Subject: Three Mile Island Nuclear Generating Station, Unit 1 (TMI-1)
Operating License No. DPR-50
Docket No. 50-289
Thermo-Lag Response to Request for Additional Information

ATTACHMENT**NRC Question:**

CB-FA-2B
1CCE-FB03
A02161.TIF

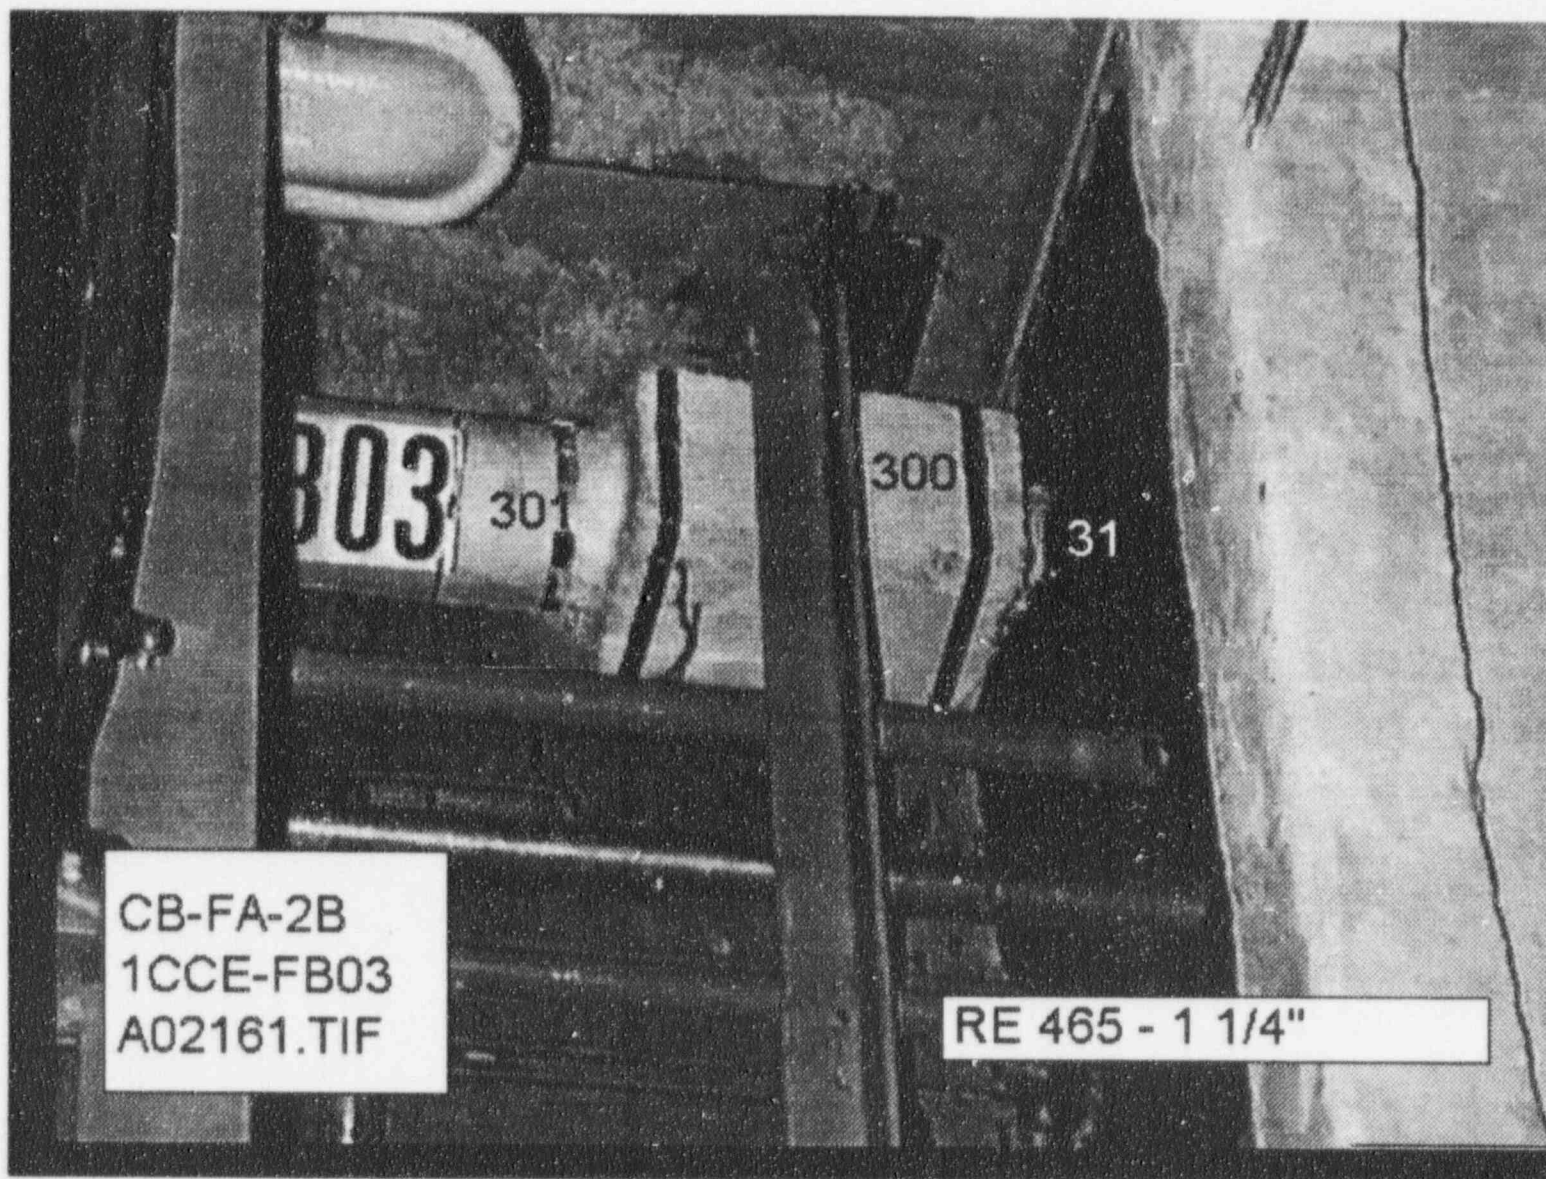
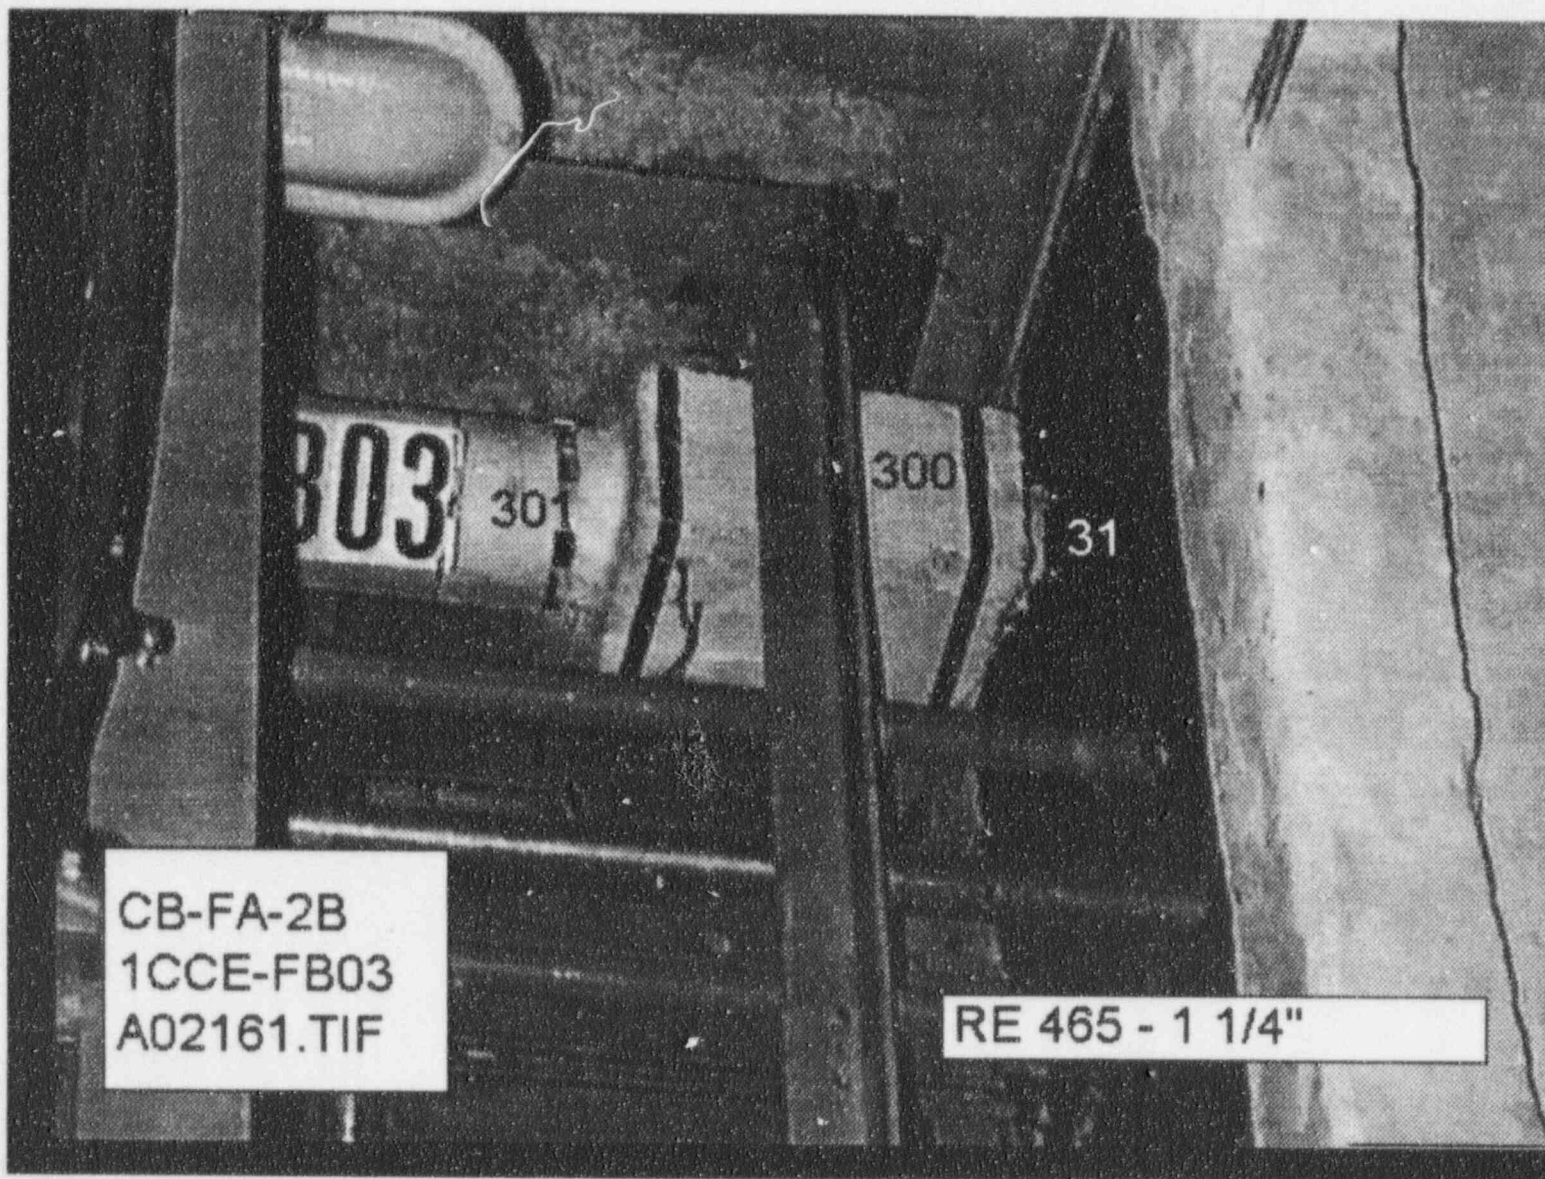
7. The following elements are listed as penetrations in Attachment 1 to Topical Report #094: 31, 573, 574, 582, 577, 578, 545, 605, and 606.

The NEI program did not test penetrations, and it is not clear from the evaluation of these elements how they are bounded by the fire tests that were discussed. Please clearly describe the configurations of these individual elements, as they are installed in the plant. Detailed drawings should be provided for further clarification. In addition, describe how these elements are bounded by the fire tests discussed in the evaluation.

The elements in question constitute elements which GPU Nuclear believes are adequately supported by NEI testing with respect to similarities in the construction of the interface point of Thermo-Lag fire barrier envelopes and the walls. Photographs of these elements are attached for information. Note that a photograph of Element 573 is not available; however, its configuration is as described below. We have modified how we designate these configurations in our electronic data base based upon our conference call of December 4, 1996. These configurations are now referred to as penetration interfaces in lieu of penetrations.

Elements 573, 574, 582, 577, 578, 545, 605 and 606 consist of interface joints at concrete walls where Thermo-Lag terminates at the wall and is joined to the wall by pre-buttering the end of preformed Thermo-Lag with trowel grade and attaching to the wall or installing a "picture frame" on the wall and abutting the end of a preformed panel to the picture frame as in Element 545. NEI Tests 3-1 and 3-2 used similar interface joints which were not the cause of the test failures. Therefore, it is concluded that a pre-buttered Thermo-Lag to concrete interface joint is not a potential weak link and has been shown to provide protection for at least 60 minutes for 1"-thick Thermo-Lag based upon the results of the aforementioned NEI tests.
